TENDER T-2025-30

Dark Bay Road Bridge Replacement

ADDENDUM #2

MUSKOKA, ON
 DRAWING TITLE
**NEW CONSTRUCTION
 PLAN & PROFILE**

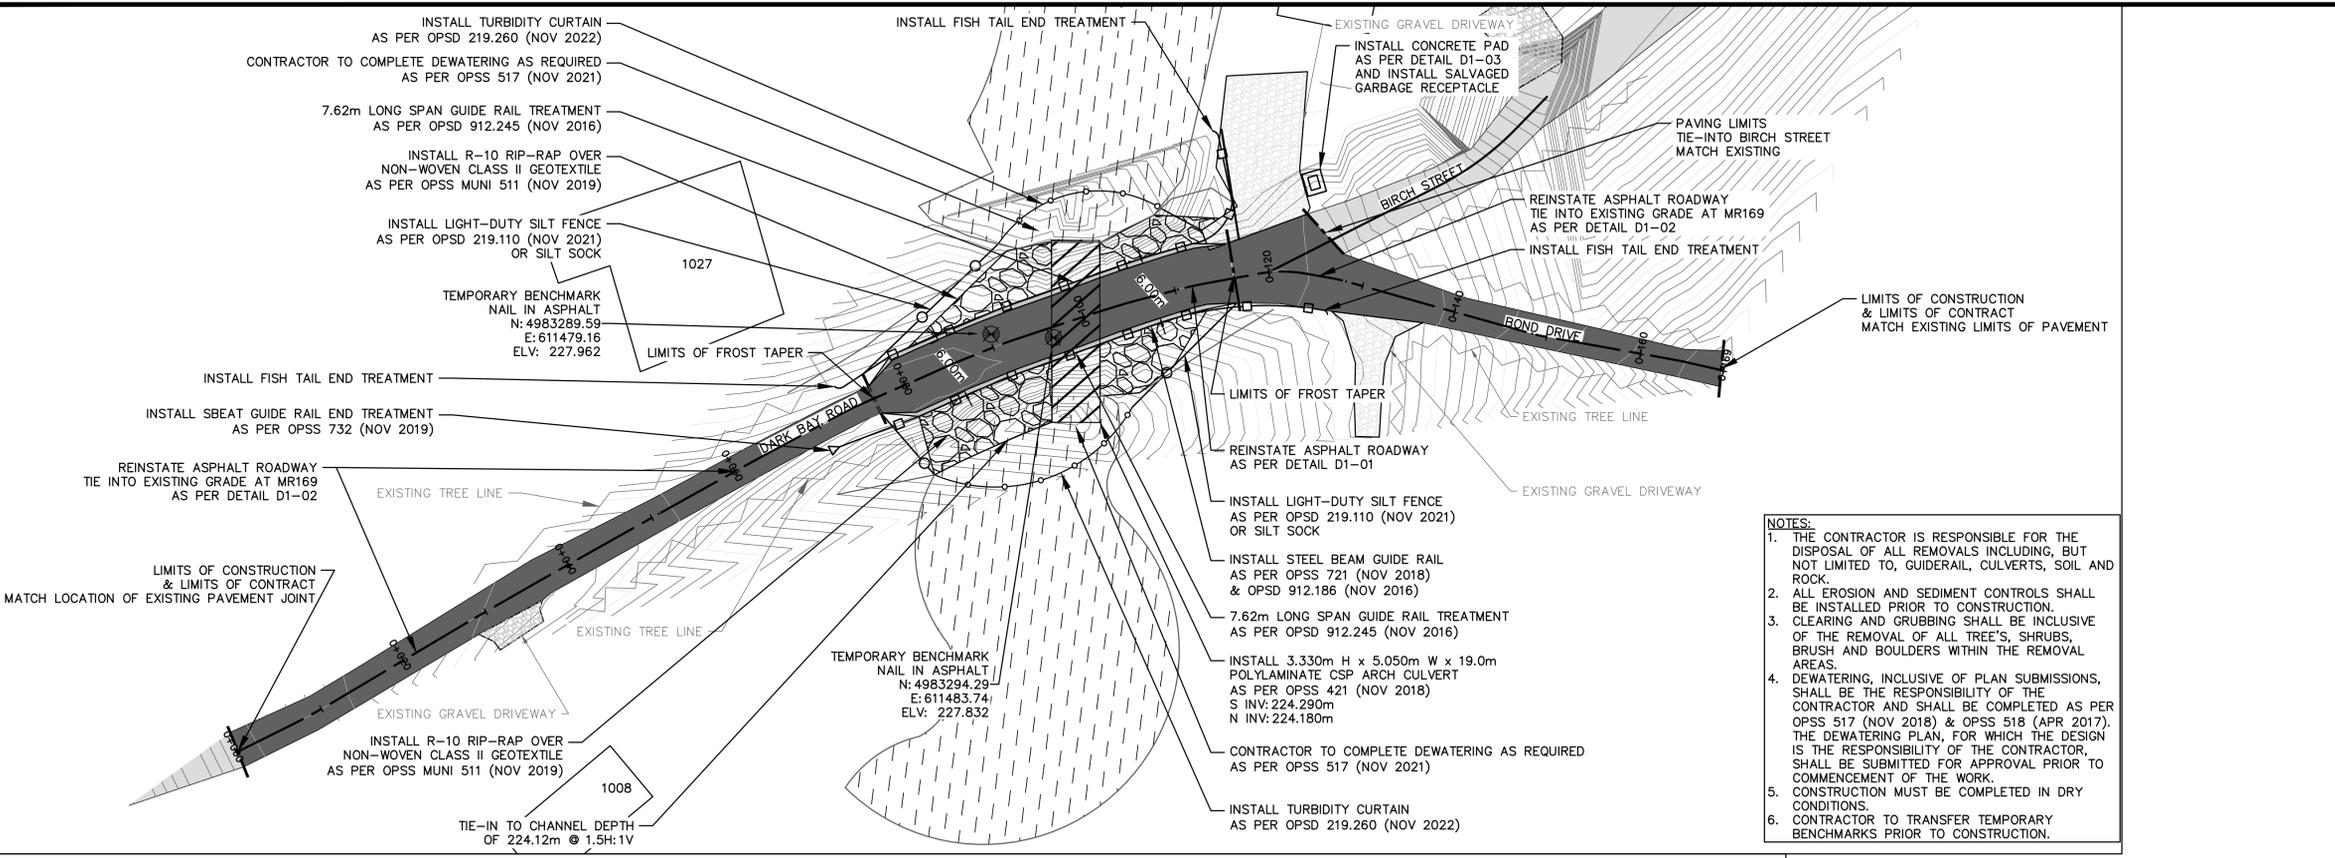
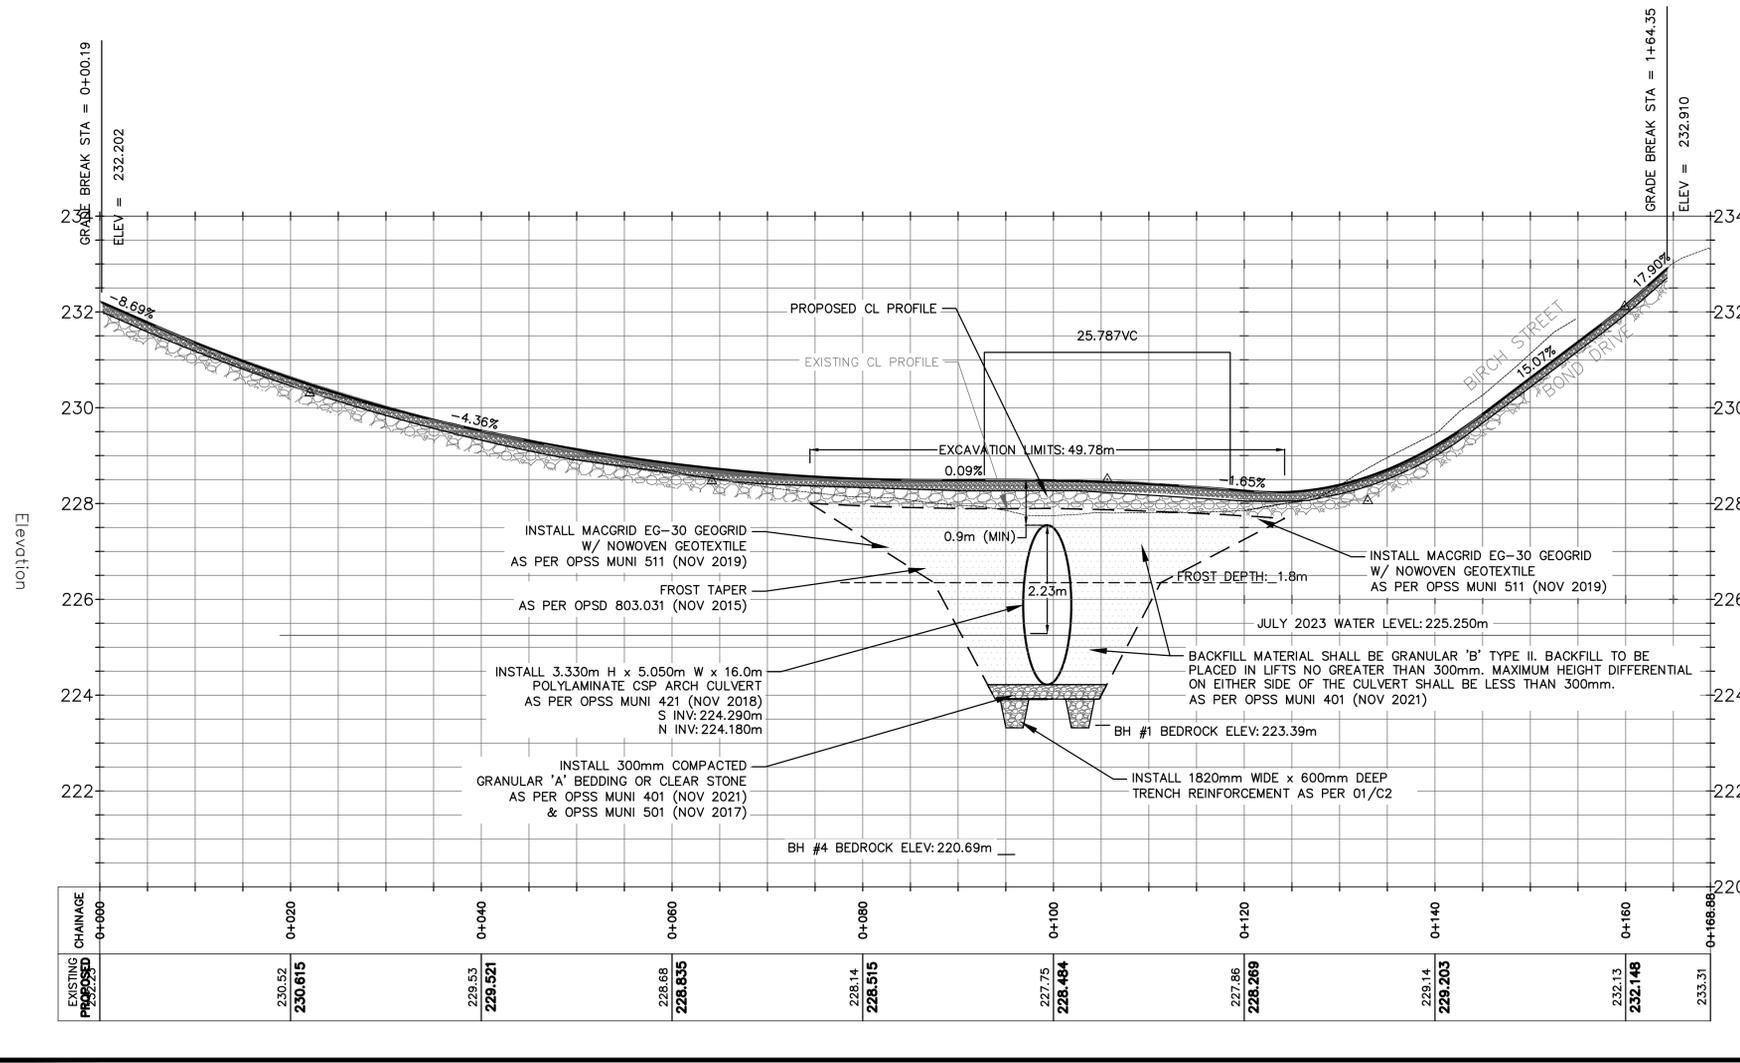
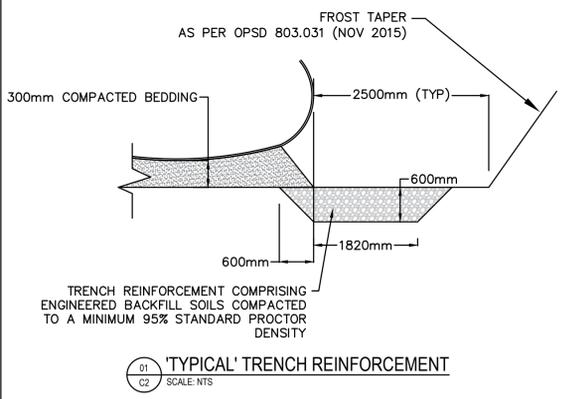
A revised set of Contract Drawings has been appended to this Addendum to reflect the changes outlined in Addendums #1 and #2. Contractors should take note of the revisions to the culvert excavation and backfill envelope as this has been updated to reflect CHBDC standards.

Q1. Minimum required height of cover according to CHBDC is 900 mm, while a height of cover of approximately 600 mm seems to be shown in the tender drawings (Drawing C2). Please clarify.

Q2. On the elevation view of Drawing C2, clear stone is indicated as a potential bedding material. Shop drawings for the pipe arch structure would not specify clear stone for 300 mm of depth below the pipe arch structure.

Q3. If Granular 'B' Type II is planned for backfill around the pipe arch, the material may not meet the requirements set out on the shop drawings. Also, "Granular 'B' Type II" is mentioned in the drawings and "Granular B" is in the tender document under Item No. 4, which may be a discrepancy

R1. The structure cover has been revised to 900 mm. A revised set of Contract Drawings is being issued with this addendum.

R2. The intent is to use compacted granular 'A' for bedding material. Clear stone is only to be utilized at the discretion of the Contract Administrator if completely dry conditions cannot be achieved.

R3. In the case of discrepancies for backfill material properties between the Contract Drawings and submitted Shop Drawings, the Contract Drawings will govern. Embedment, cover and backfill material is to be Granular B Type II with 100% passing the 26.5 mm sieve as per OPSS 401.
